May 6, 2024

**Re: Revised Remediation Work Plan ADDENDUM
ConocoPhillips Company (Heritage COG Operating, LLC)
Way South State Com #001H Tin Horn Release
Unit Letter A, Section 30, Township 26 South, Range 28 East
Eddy County, New Mexico
Incident ID# nAB1821441824
Landowner: NMSLO**

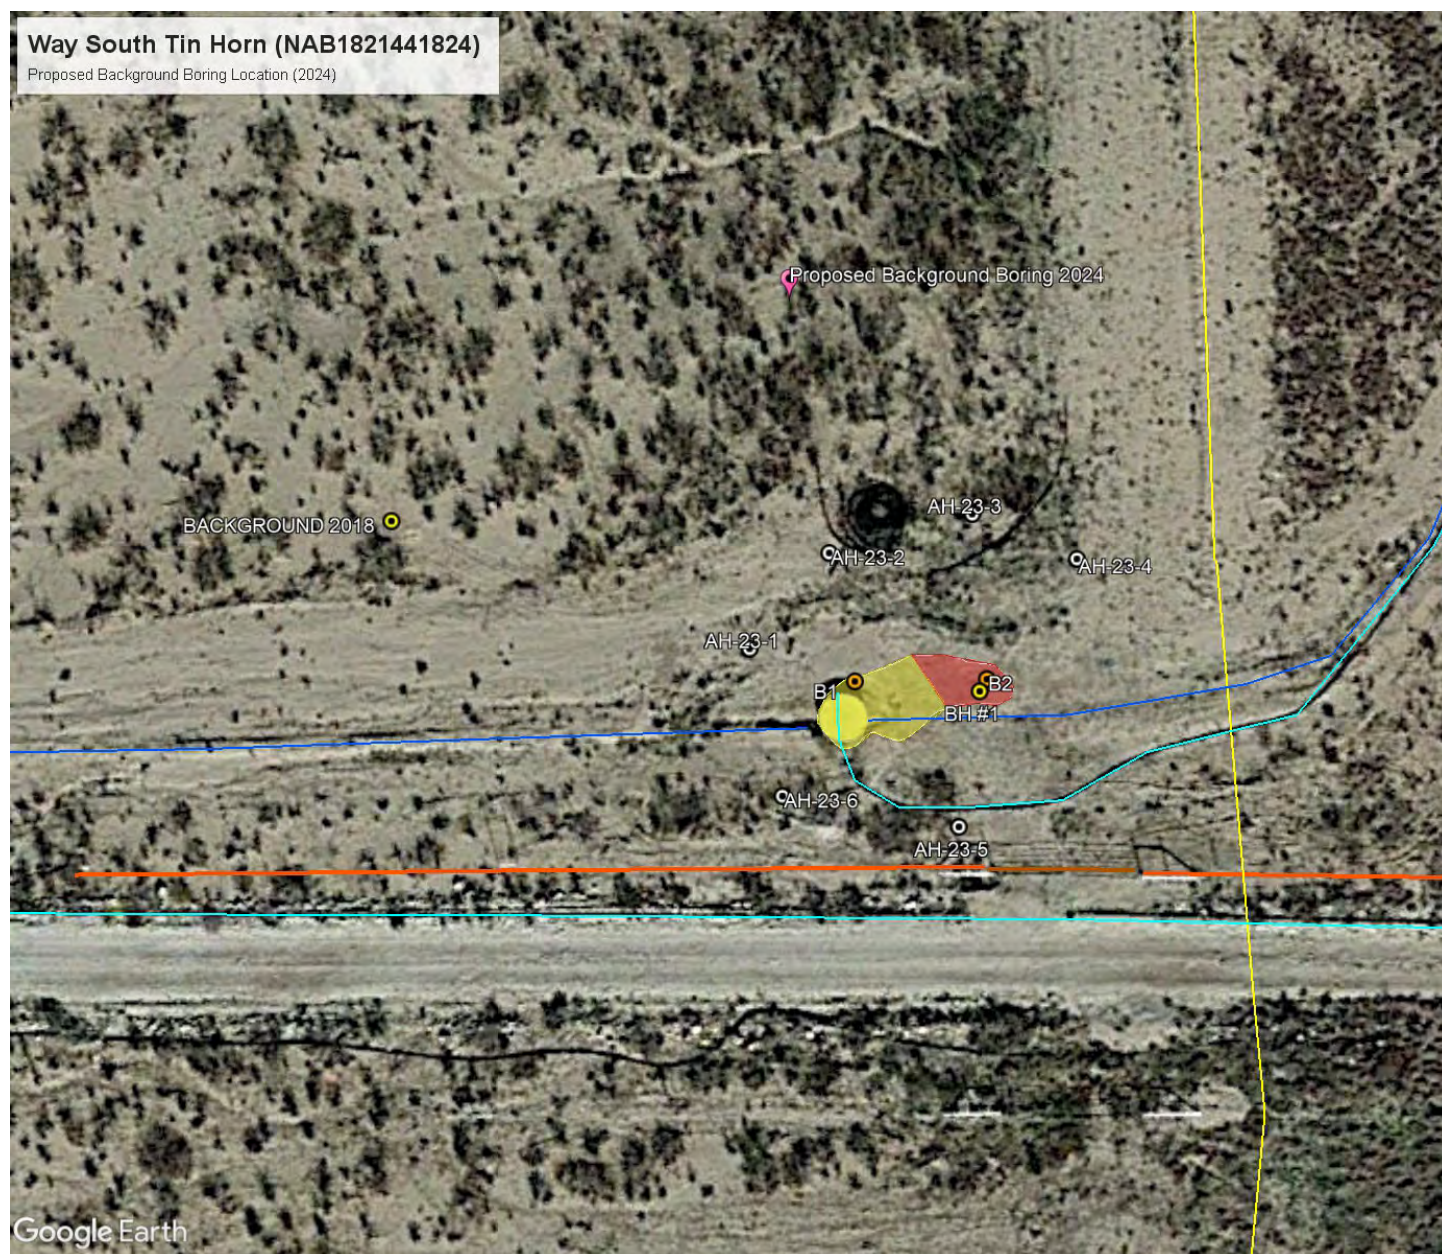
Based on the below correspondence from NMSLO ECO, and the attached correspondence from the NMOCD, a joint conference call was held on 1/5/2024 to discuss the ideal placement for the requested additional background soil boring.

After review of the site conditions in the vicinity of the tin horn and the right-of-way, a location approximately 100 feet due north of the release extent (presented in the image below) was selected for the background boring. That location

was agreed upon by Tami Knight of NMSLO ECO and Brittany Hall of NMOCD. The approximate GPS coordinates of the new proposed background boring are 32.018888°, -104.120315°.
